Groundwater Transfer Review Summary Form

Transfer/PA # T- <u>14339</u>

OREGON			Ground Water Review Form:			
WATER RESOURCES D E P A R T M E N T	Oregon Water Resou 725 Summer Street NI Salem, Oregon 97301- (503) 986-0900 www.wrd.state.or.us	E, Suite A	 ☑ Water Righ □ Permit Ame □ GR Modifie □ Other 	endment		
Application: T- <u>14</u>	339		Applicant Name: Bell A Land and Cattle Co.			
Proposed Changes	s: \Box POA \Box USE	⊠ APOA □ POU	$\Box SW \rightarrow GW$ $\Box OTHER$	RA		
Reviewer(s): <u>Grayson Fish</u>			Da	te of Review: <u>10/</u>	31/2024	
			Return	ed to WRSD: 10/	31/2024

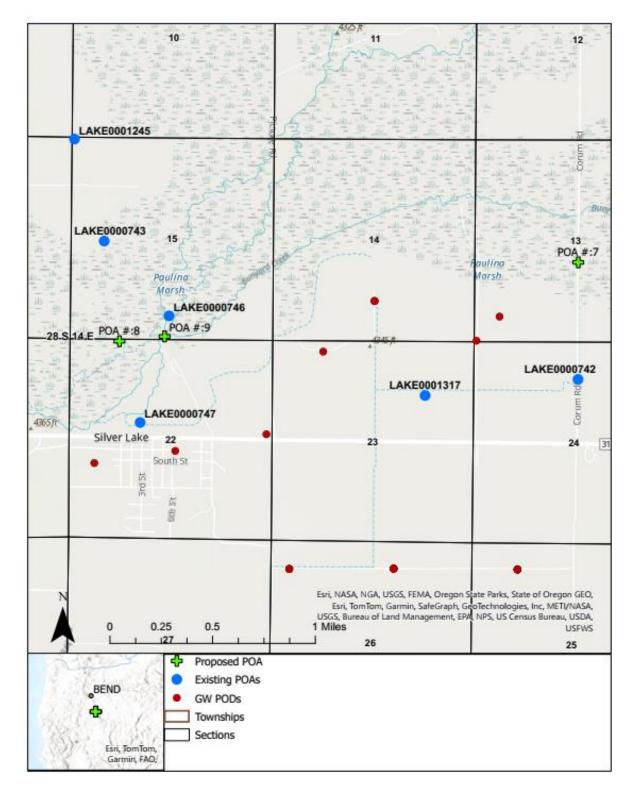
5. a) Will this proposed change, at its maximum allowed rate of use, likely result in an increase in interference with another ground water right?
☑ Yes □ No Comments: <u>All existing wells on these certificates are closer to existing wells on other water rights than the unbuilt POA 7-9. However, increasing the maximum pumping rate allowed on existing wells is likely to result increased interference with nearby existing groundwater rights.</u>

\Box Yes \boxtimes No If yes, explain: The POA closest to other nearby water rights is LAKE 747 which is approximately 1,150 feet from the POA associated with certificate 66477. If this transfer is approved, the maximum pumping rate allowed under all water rights on LAKE 747 would be 4.66 cfs.

The potential drawdown was calculated using the Theis equation (attached). The values used for the calculation are conservative and appropriate until better values become available. The calculation used an intermediate storage coefficient (0.001). The transmissivity used in the calculation (15,000 ft²/day) is from Morgan (1988) and McFarland and Ryals (1991). At the maximum allowed pumping rate (4.66 cfs), the results indicate a drawdown of ~18 feet, which would not meet the standard of "substantial or undue interference".
